TN_161

FT4222H Errata Technical Note

Version 1.7

Issue Date: 21-11-2024

Figure 3.2 Quad SPI without Multi Write Phase

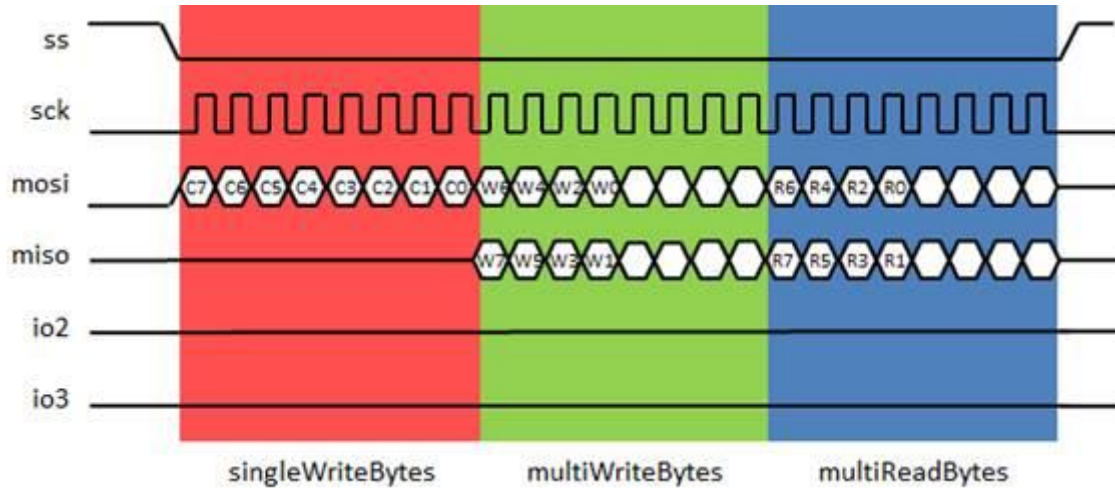
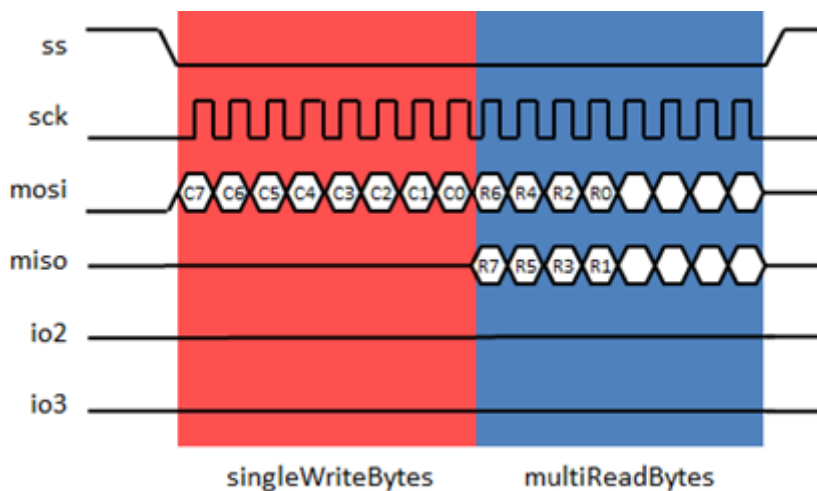
When accessing Toshiba flash with SPI Master Quad mode, FT4222H will hang without giving any responses.

FT4222H operates as master with supporting Dual or Quad SPI with three phases as illustrated in **Figure 3.1**.

As shown in **Figure 3.1**, 'C', 'W' and 'R', correspond to "Command Phase", "Write Phase" and "Read Phase", where there are information/data in all three phases that are to be exchanged.

Some flash devices operate with single write and multi read protocol but without the multi write phase as illustrated in **Figure 3.2**:

Write Phase has no information/data to transfer. This combination of operating mode is not supported with Revision A, B, and C.

In SPI Master Quad mode, the operation of single write with quad read was not supported. No workaround was provided, this feature is implemented with Revision D.

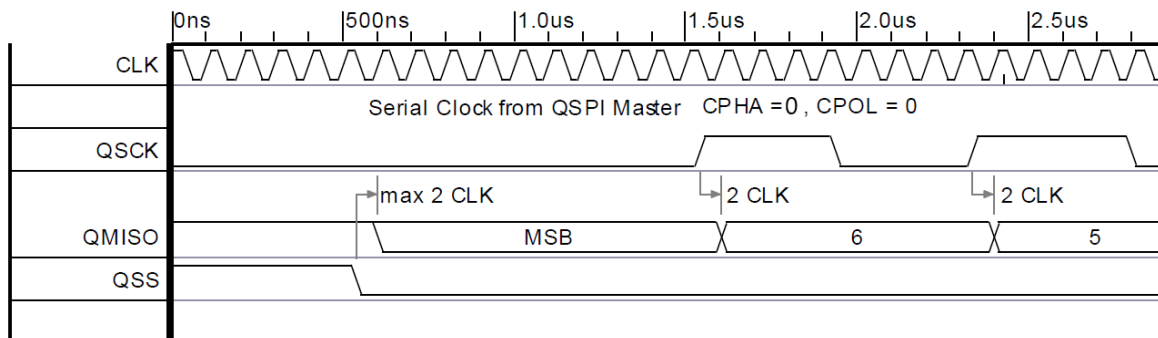
The data output of FT4222 in SPI slave mode does not comply with the well-known SPI spec. MISO change the data polarity at wrong timing.

The SPI spec defines CPHA and CPOL to configure the clock polarity and phase with respect to the data. CPHA decides when MISO pin changes the IO polarity.

1. The first data bit is outputted immediately when CS activates.
2. The MISO changes IO polarity on trailing phase to make sure the data can be got the correct data on leading phase.

The issue happens on item 2.

As shown in the diagram below, FT4222 changes the IO polarity after 2 CLK (25ns) after leading phase happens. This issue may not cause problem when SPI Master is a hardware decode IP. However, if the SPI Master is a MCU base design with low sampling rate, the master might retrieve the wrong data.

Currently, there is no workaround for this issue. When leading phase happens, the SPI master needs to retrieve data as soon as possible. If the process cannot finish in 25ns, the data will be overwritten by the next data bit.

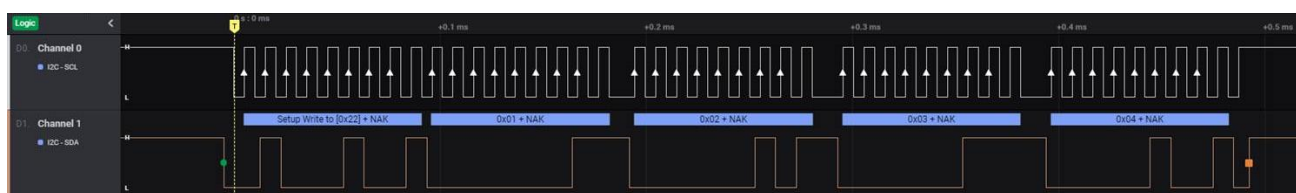
As shown in the diagram below, the I2C master of FT4222 executes the request from the host that writes four bytes 0x01, 0x02, 0x03, 0x04 to the I2C slave with address 0x22. Even though FT4222 gets NAK following the address byte, FT4222 still sends out all data. In theory, the data transmission should be terminated upon receiving an NAK.

N/A.
